# NTUA Headquarters Complex Office Building

Dyron Murphy Architects Project No. 2015.05

## ADDENDUM No. 1

October 27, 2016

1

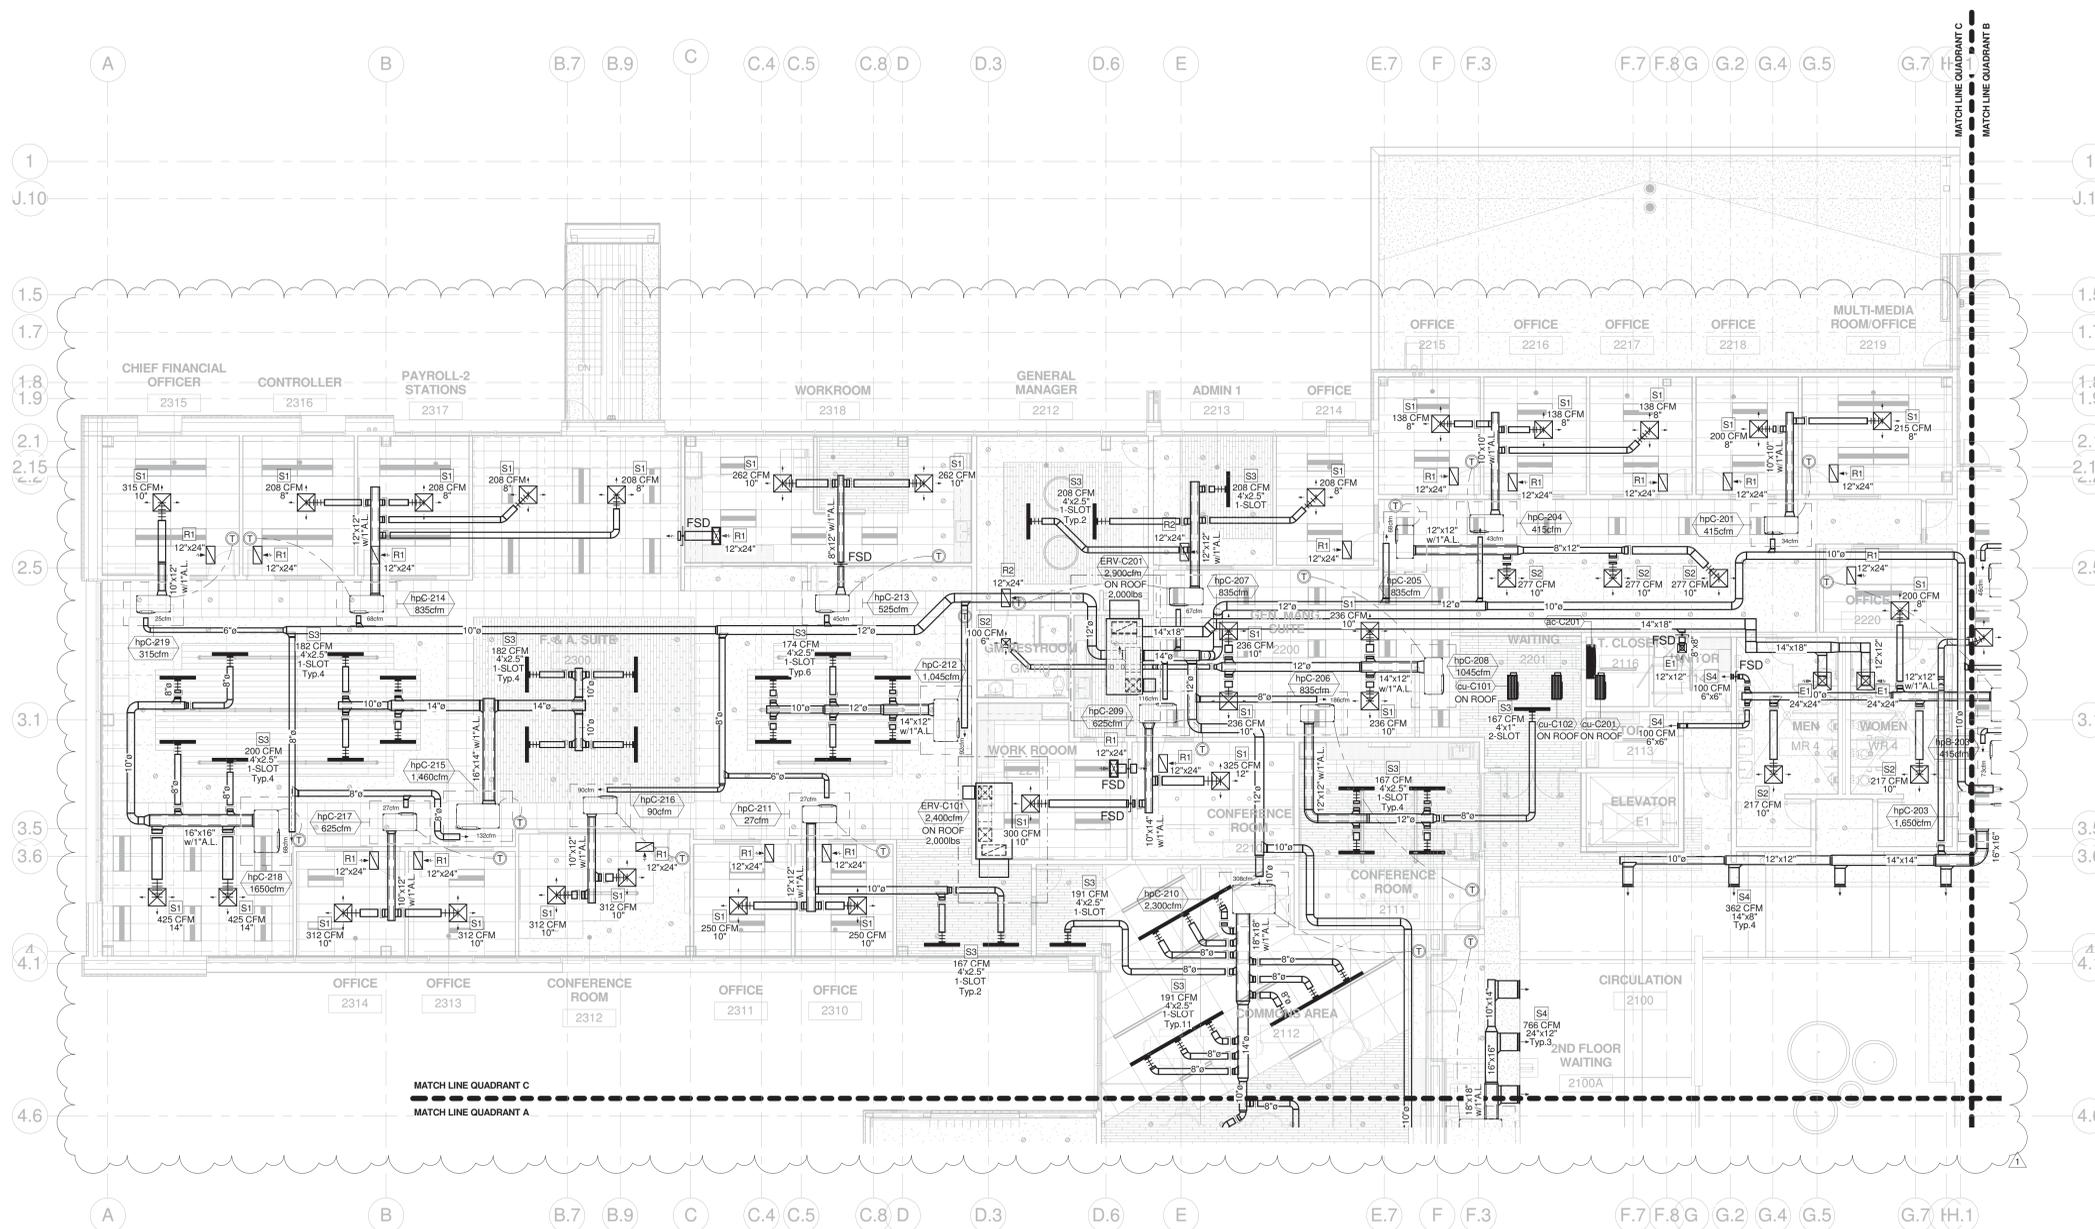
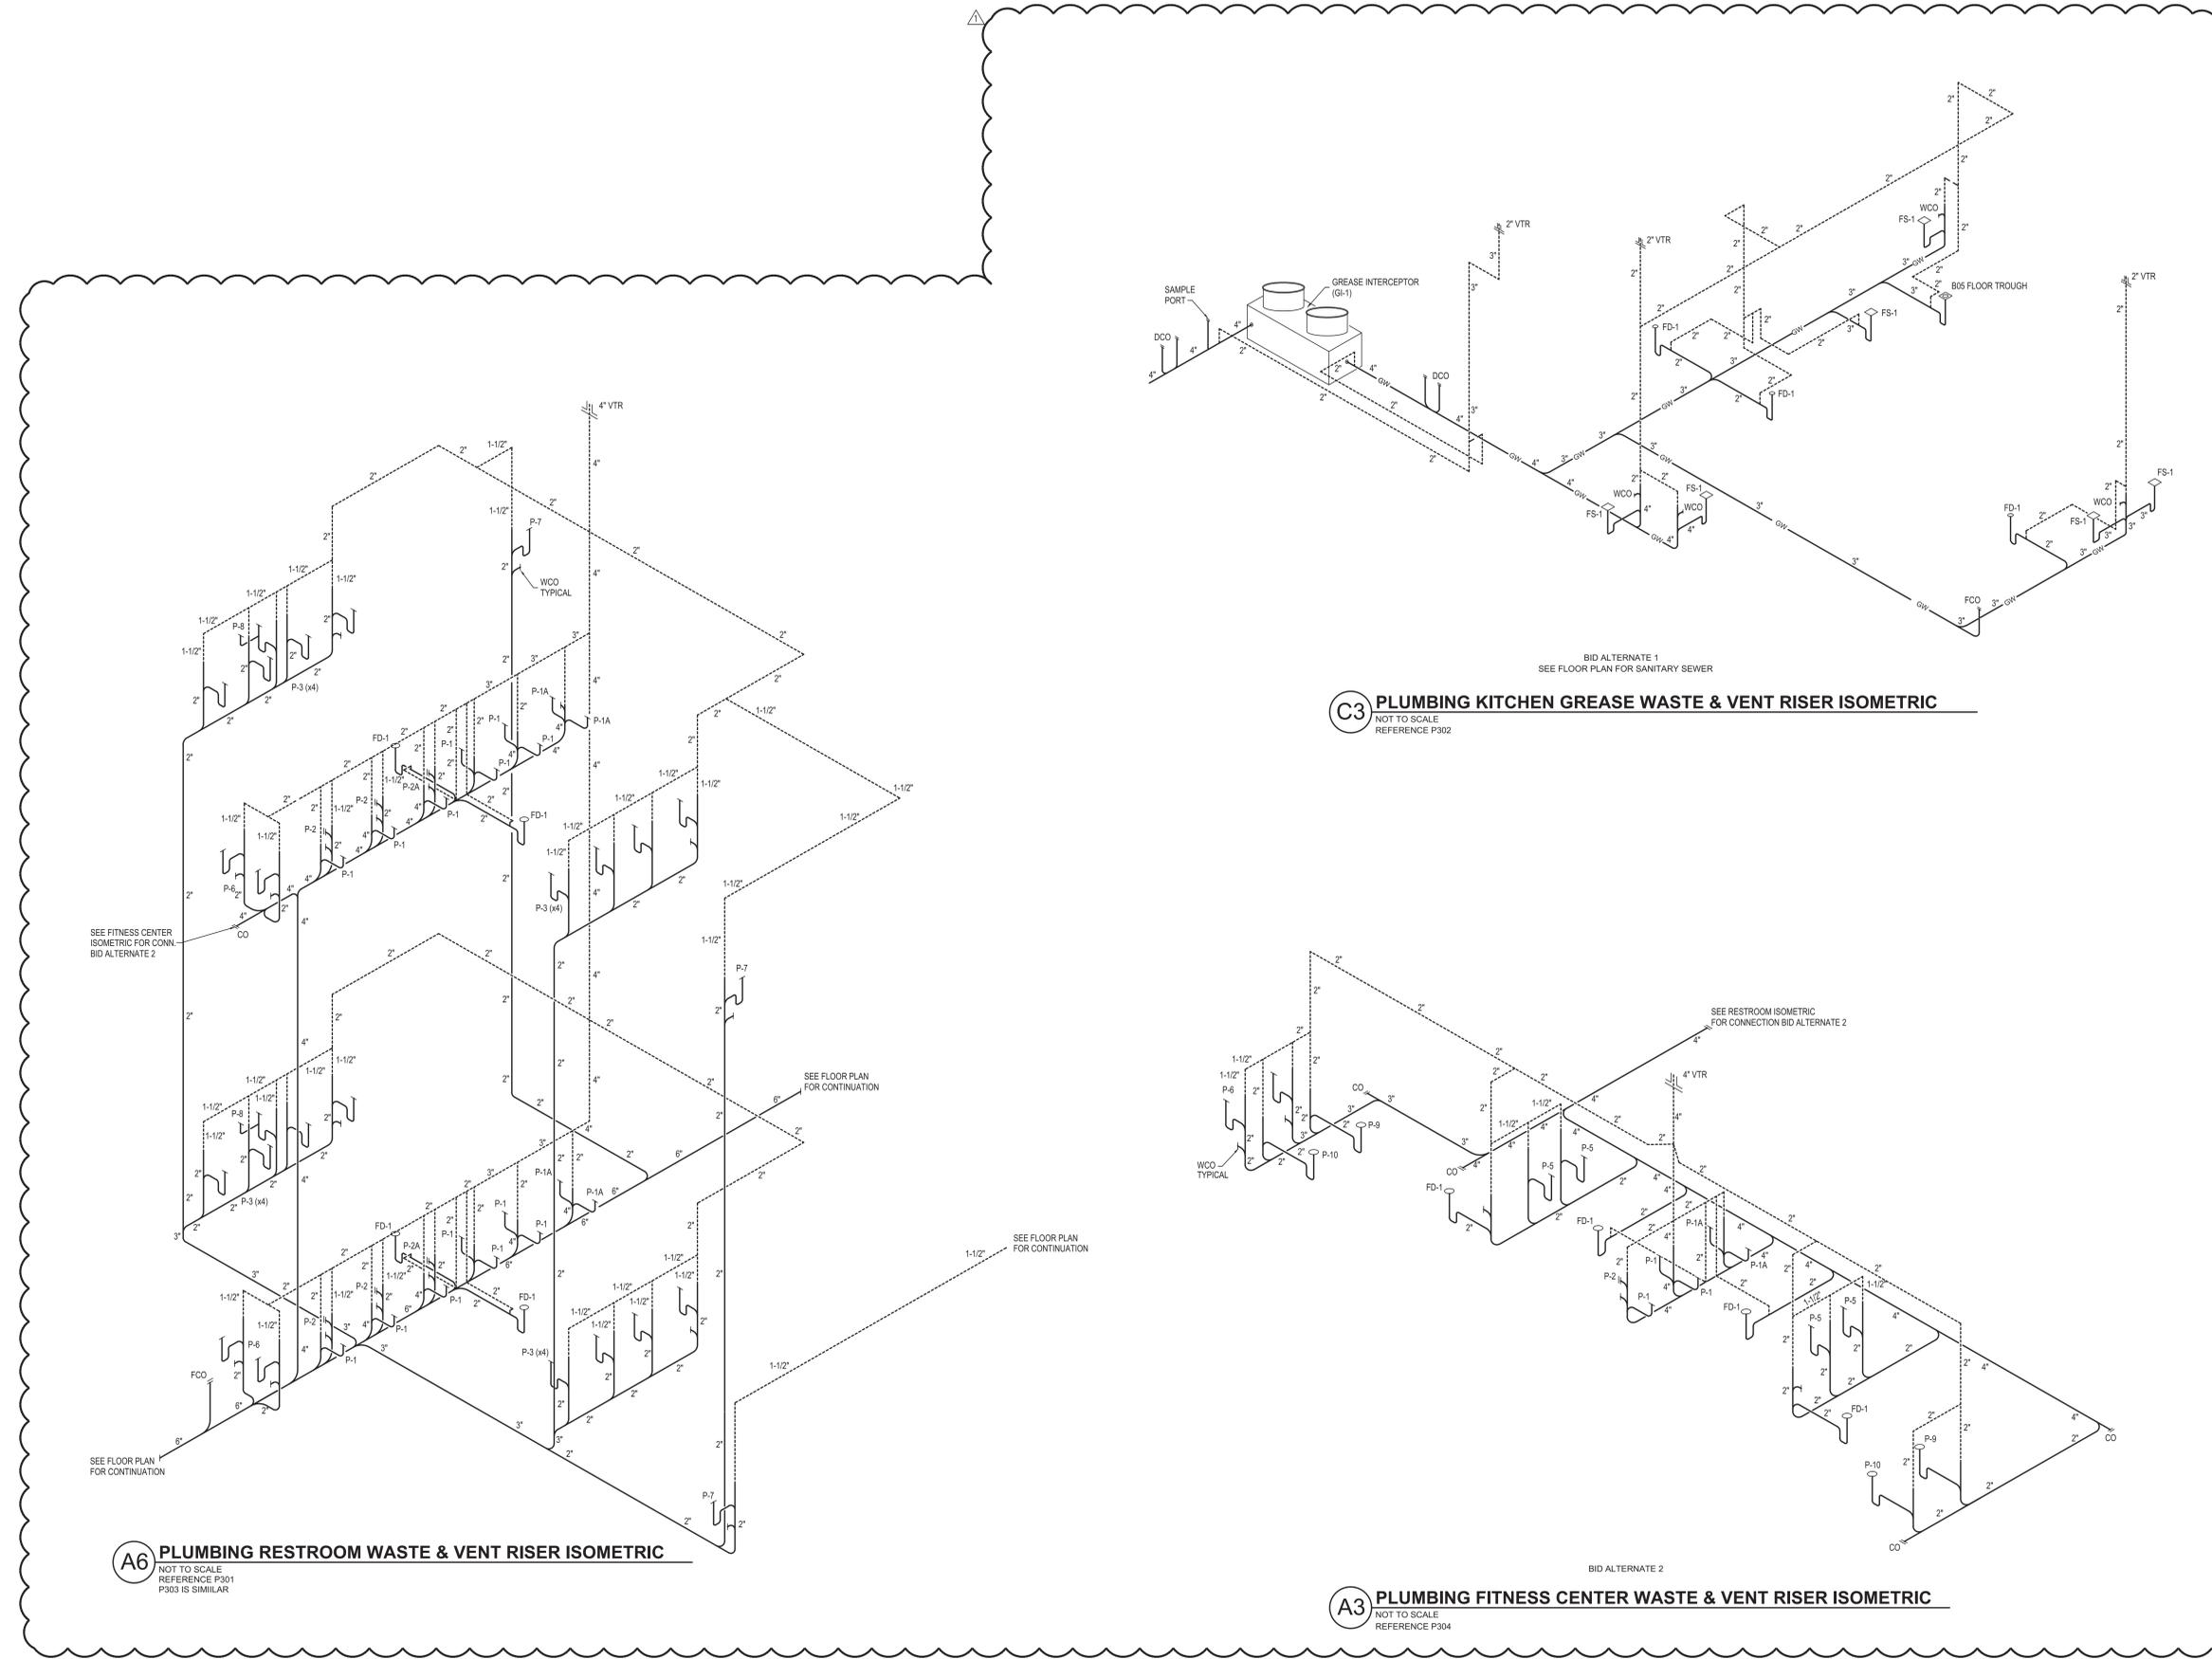
Drawing M102 MECHANICAL OVERALL 2 <sup>nd</sup> FLOOR HVAC PLAN	- REVISES: Outdoor Air Ventilation ductwork sizes & cfm capacities.
Drawing M102a MECHANICAL 2 <sup>nd</sup> FLOOR HVAC PLAN – QUADRANT A	- REVISES: Outdoor Air Ventilation ductwork sizes & cfm capacities.
Drawing M102b MECHANICAL 2 <sup>nd</sup> FLOOR HVAC PLAN – QUADRANT B	- REVISES: Outdoor Air Ventilation ductwork sizes & cfm capacities.
Drawing M102c MECHANICAL 2 <sup>nd</sup> FLOOR HVAC PLAN – QUADRANT C	- REVISES: Outdoor Air Ventilation ductwork sizes & cfm capacities. Supply Air ductwork and Diffuser locations in Board Room.
Drawing P305 PLUMBING WASTE & VENT RISER ISOMETRICS	- ENTIRE SHEET IS ADDED TO CONTRACT DOCUMENTS

**E5 ENLARGED COOLING TOWER ELECTRICAL PLAN**  
NOT TO SCALE

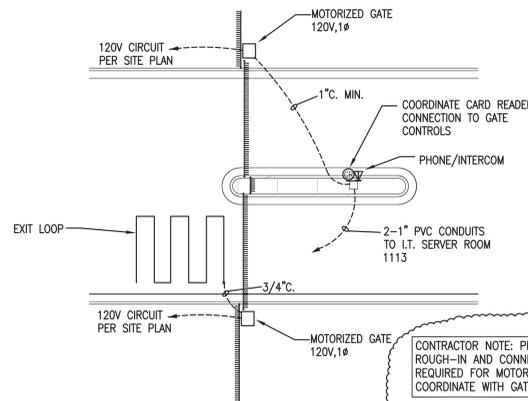
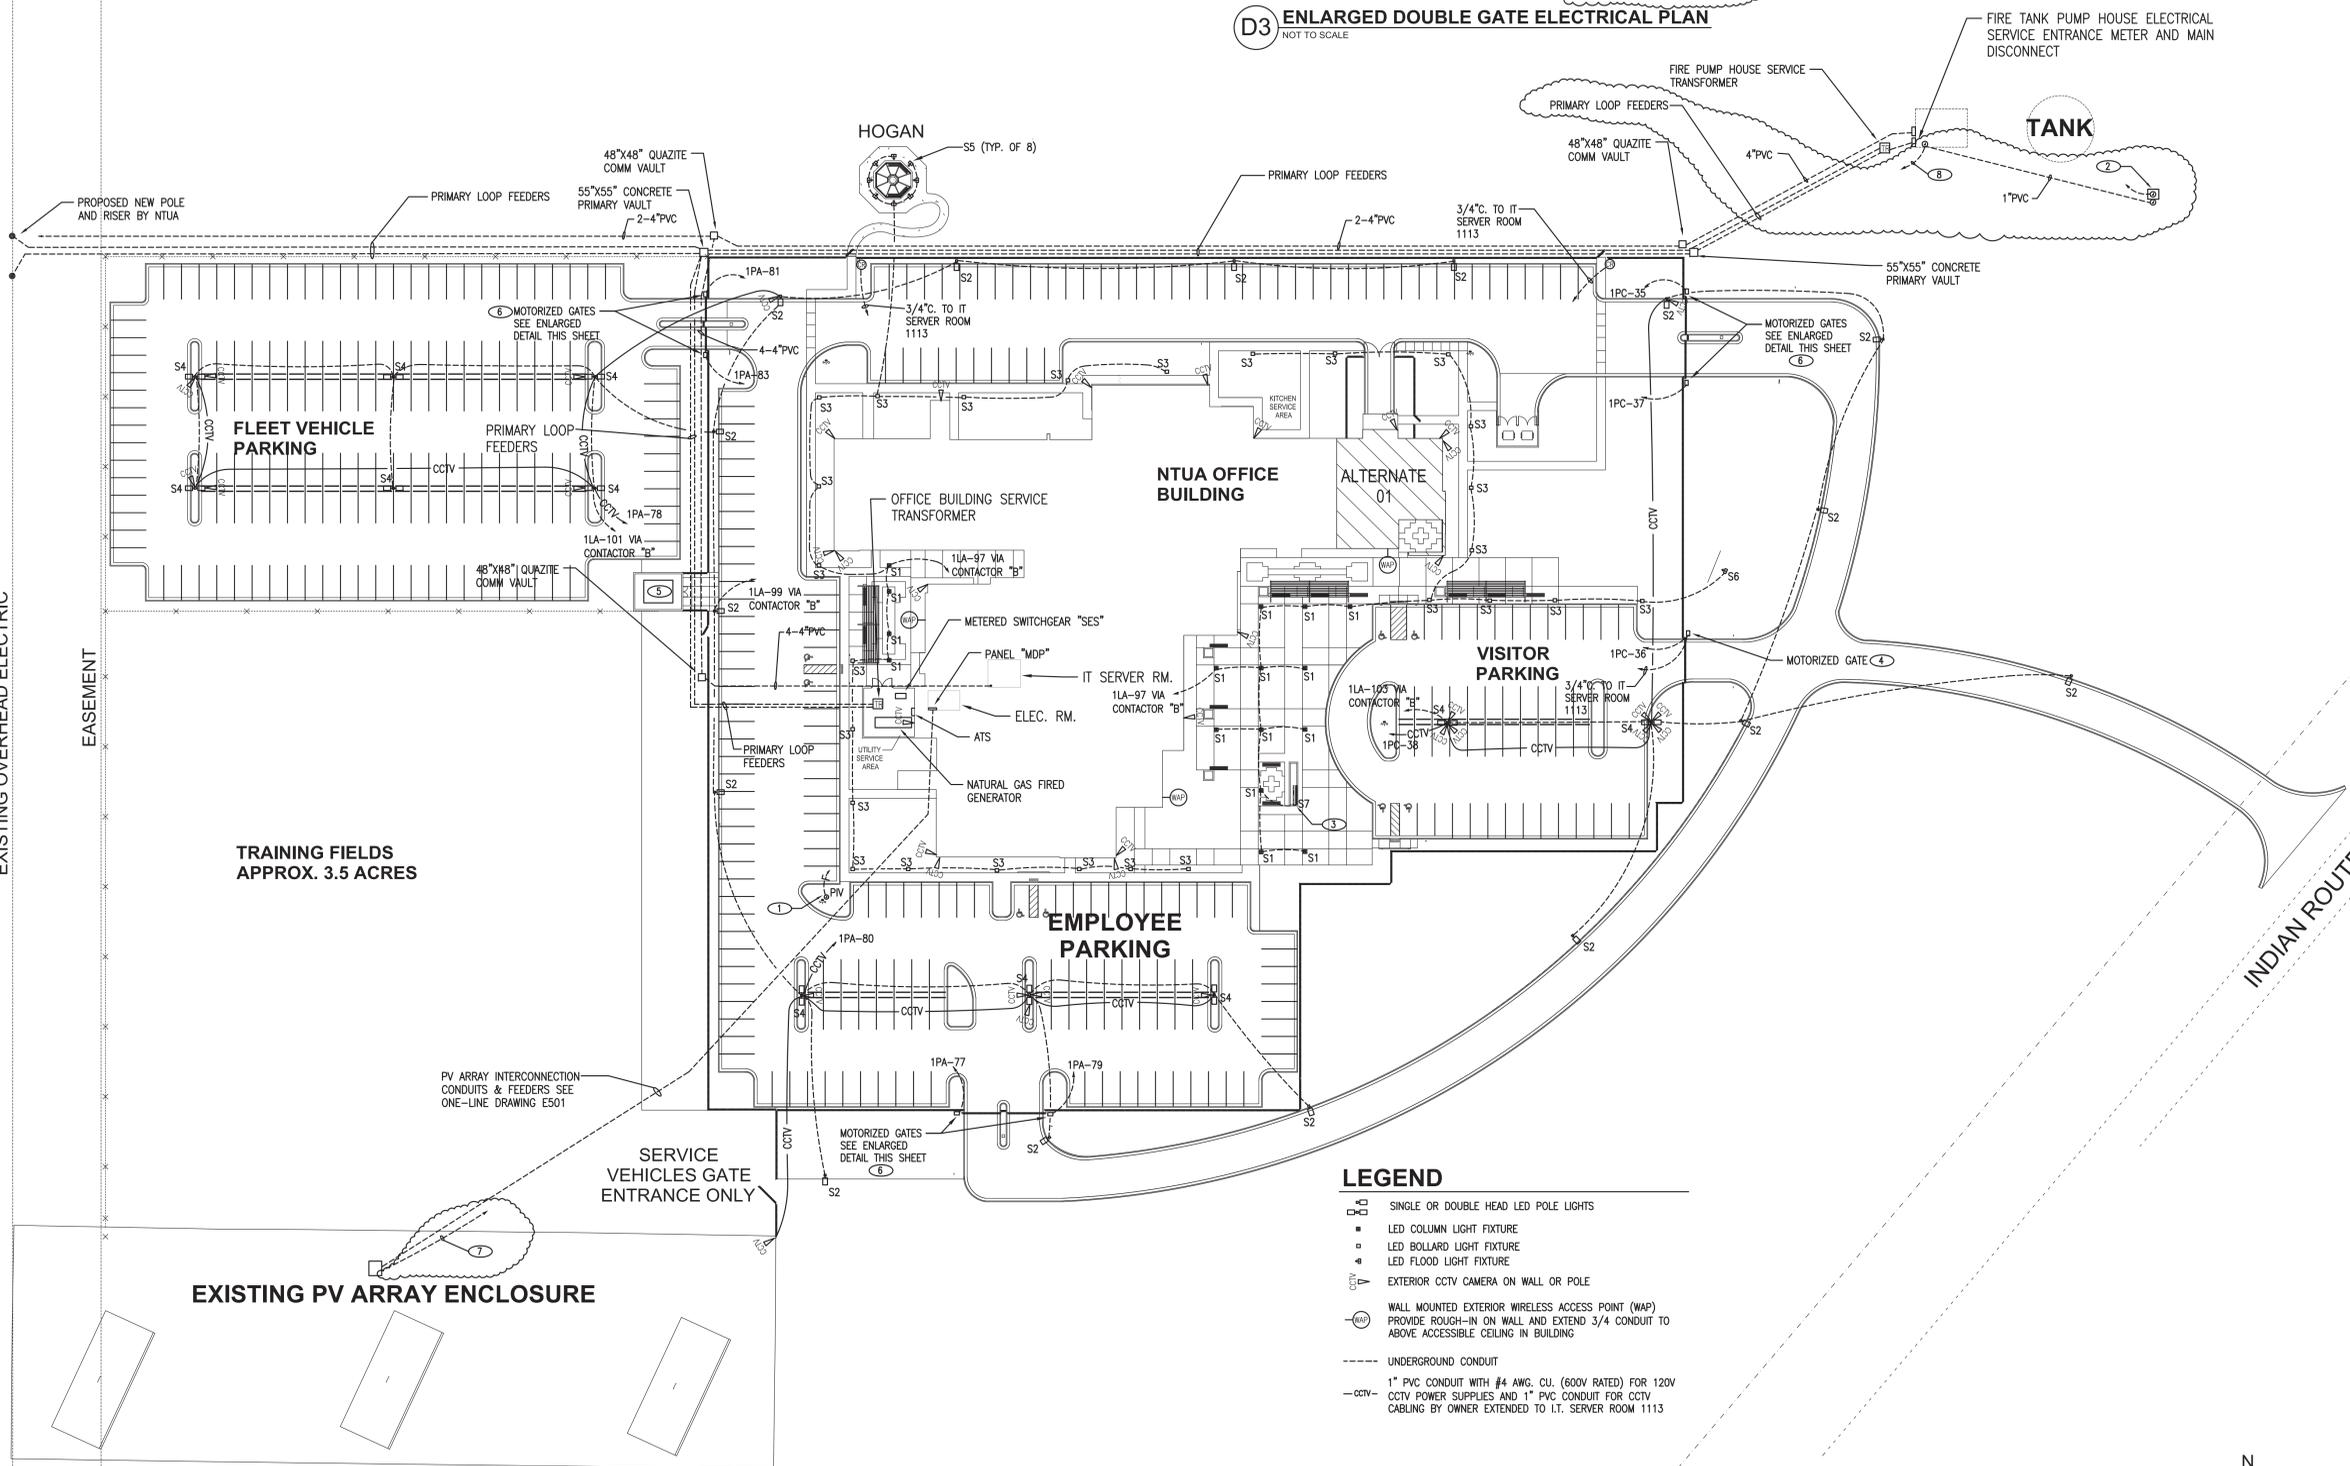
1. Sheet E001: Refer to attached Sketch SKA-E001, for Addendum items.
2. Sheets E103a, E103b and E103c: See revised sheets for Addendum items.
3. Sheets E104a, E104b and E104c: See revised sheets for Addendum items.
4. Sheet 601: Add speaker symbol and description as follows:
